Proposed drawing
only for comment

PROJECT		
Friskey pudding		
TITLE		
Proposed kitchen Vent		
CLIENT		
Vision		
DRAWN BY MP	CHECKED BY Checker	DATE 09/18/19
SCALE (@ A1) 1:25	PROJECT NUMBER 4197	
DRAWING NUMBER 001	REV

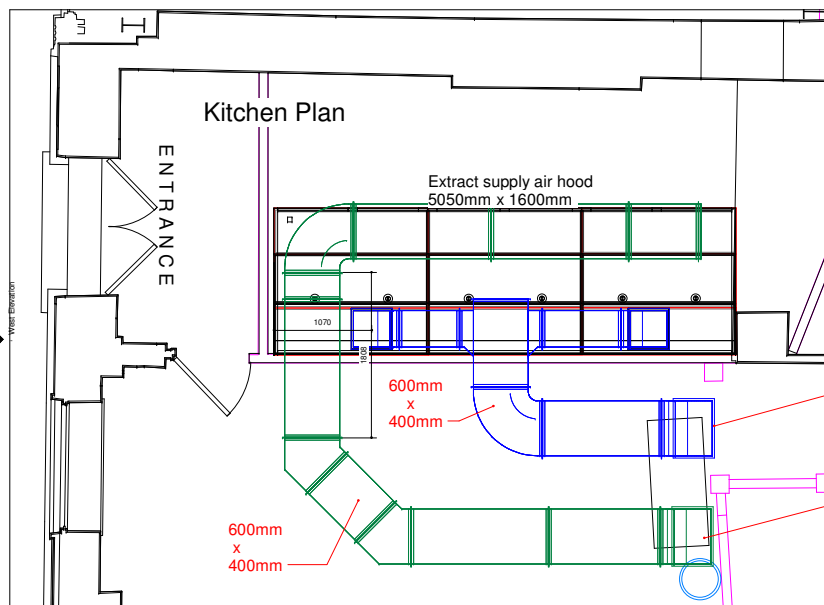
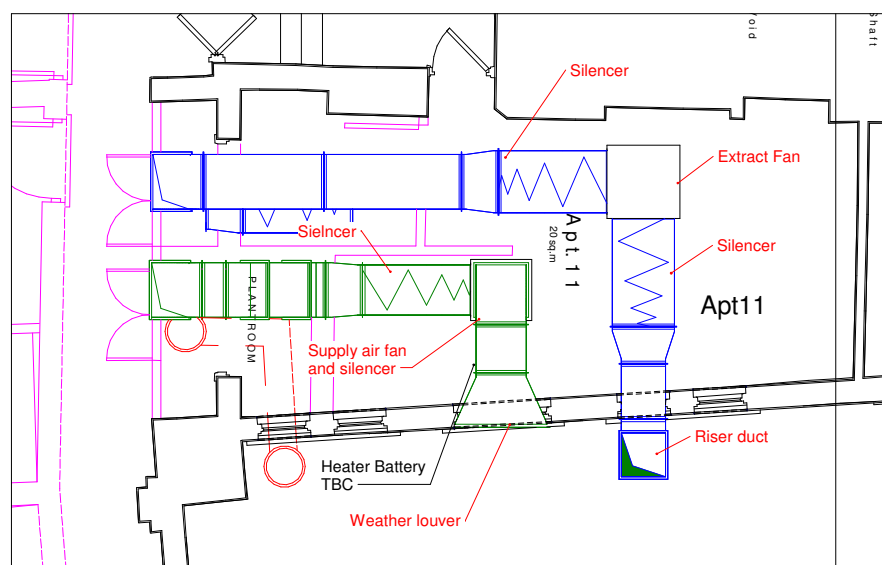
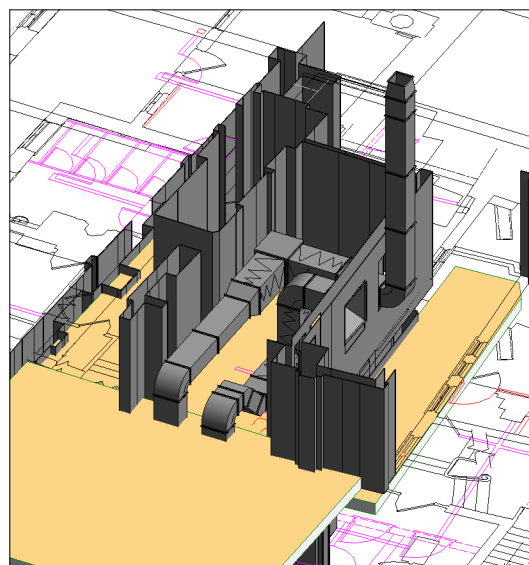
EXTRACT DUCT
(NOT FIRE RATED)
WILL REQUIRE ENCLOSING IN
FIRE RATED COMPARTMENT OR
FIRE RATED DUCT WILL BE REQUIRED
